STAFF REPORT

Case #19-05: SITE PLAN REVIEW
145 Cove Street
Map: 20 Lots: 104, 158, & 102, 103

145 Cove Street
Drive-Thru ATM (looking west from parking lot inside site)

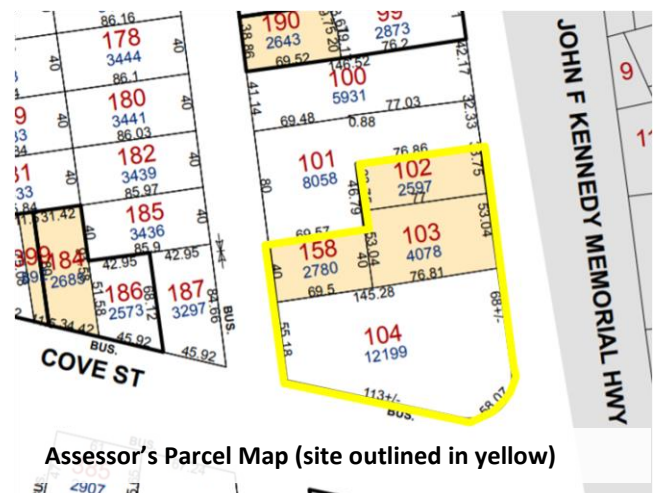
Lighting. No changes are proposed to the site lighting. There is existing lighting under the drive-thru canopy that will provide light for the new ATM unit. The board may wish to condition new lighting lens cover be installed, as the current overhead florescent tubes are exposed.

- That the following specific conditions also be applied to this decision:
 - The drive-thru florescent lighting lens cover is to be reinstalled/replaced.
